# PHILCO TV

## SCHEMATIC DIAGRAMS

MODEL 48-700 THRU 53T2750

Figure 1. Changes in Sync Separator Circuit, Run 4 of Deflection Chassis, Models 50-T1600, 50-T1632, and 50-T1633

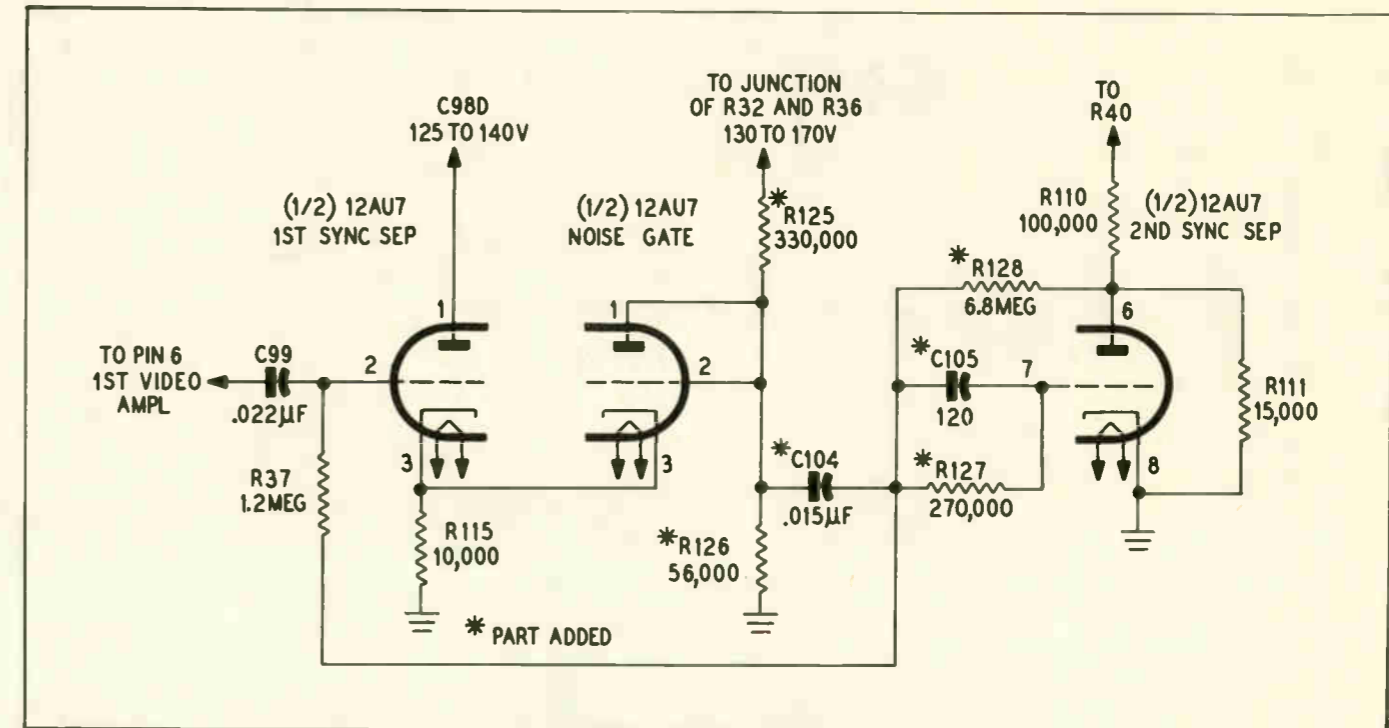
4 (Deflection)	Vertical and horizontal sync separator changed, as shown in figure 1.	66-5128340* (R109) 66-2688340* (R116) 45-3505-62* (C97) 60-10335407* (C96) 62-110009001* (C100)	45-3505-59* (C104) 60-10125237* (C105) 66-4338340* (R125) 66-3568340* (R126) 66-4278340* (R127) 66-5688340* (R128)	To improve sync performance in weak-signal areas.
4 (Deflection)	R53, 10,000-ohm resistor, 4-watt, changed to 5-watt.	66-3104340*	66-3105340*	To prevent overload with high line voltage.
4 (R-f, i-f)	39-ohm resistor in series with 22.1-mc. trap (L6), changed to 15 ohms (added in Run 2).	66-0398350*	66-0158350*	To change 22.1-mc. trap attenuation.
4 (R-f, i-f)	100- $\mu\mu\text{f}$ . condenser added, from pin 5 of Z3 to ground.		62-110009001*	To improve AM rejection of FM detector.
4 (R-f, i-f)	56- $\mu\mu\text{f}$ . condenser added, from pin 2 of video output tube (6AQ5) to ground.		62-056409001*	To reduce lead radiation.

DESCRIPTION OF CHANGE	REMOVED PART NO.	ADDED PART NO.
1. Voltage-divider resistor R73, in plate circuit of sync inverter, changed to 5600 ohms. Voltage-divider resistor R70 removed. Voltage-divider resistor R74 changed to 2700 ohms.	66-3108340* 66-3228340* 66-2478340*	66-2568340* 66-2278340*
2. Horizontal-oscillator grid blocking condenser, C84, changed to silver mica type.	60-10275407*	60-10275317*
